April 15, 2010
U7-C-STP-NRC-100084

South Texas Project
Units 3 and 4
Docket Nos. 52-012 and 52-013
Response to Request for Additional Information

RAI 03.02.02-10**QUESTION:**

RAI 03.02.02-11**QUESTION:**

Figure 3.0-1 UHS and Reactor Service Water System

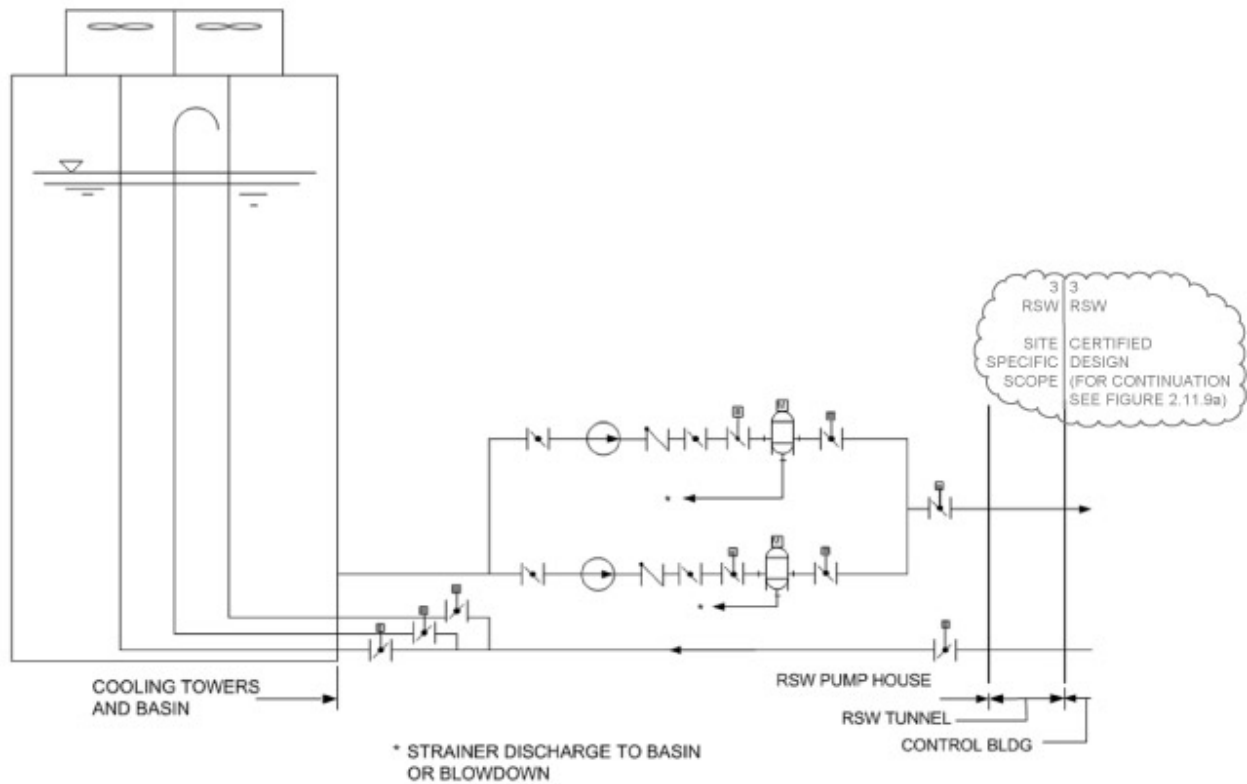
Rather than including a licensing commitment to update the FSAR figures to include the QG, the response to RAI 03.02.02-2 references the Tables for QG classifications. Although NRC staff can audit detailed P&IDs during the detailed design stage, QG boundaries should also be shown on the simplified P&IDs in the COL FSAR. SRP 3.2.2 states that the P&IDs are reviewed to ensure that the applicant has delineated in detail the system quality group classification boundaries for systems important to safety and SRP 14.3 Appendix C states that the functional drawings identify the boundaries of the ASME Code classification that are applicable to the safety class. Considering the revised response to RAI 03.02.02-6 relative to ITAAC, a licensing commitment should also be cited by the applicant to update FSAR figures for P&IDs prior to fuel load, including an appropriate implementation schedule. If the applicant plans to include the quality group/ASME Code boundaries during the annual updates the staff will defer this review of P&IDs until later.

The site specific representation of the Ultimate Heat Sink (UHS) and Reactor Service Water System is included in COLA Part 9, Section 3.0, Site-Specific ITAAC as Figure 3.0-1. Although the figure used the Tier 1 line symbol representative of ASME Code Class 3 for the piping, there was no Appendix A “designation” that correlated to that classification because there are no code breaks on this figure.

To provide additional clarity, COLA Part 9, Section 3.0, Figure 3.0-1 will be revised to add the ASME Code Class 3 designation to piping on this diagram as indicated in a gray balloon on the attached figure. There are no QG breaks on this figure.
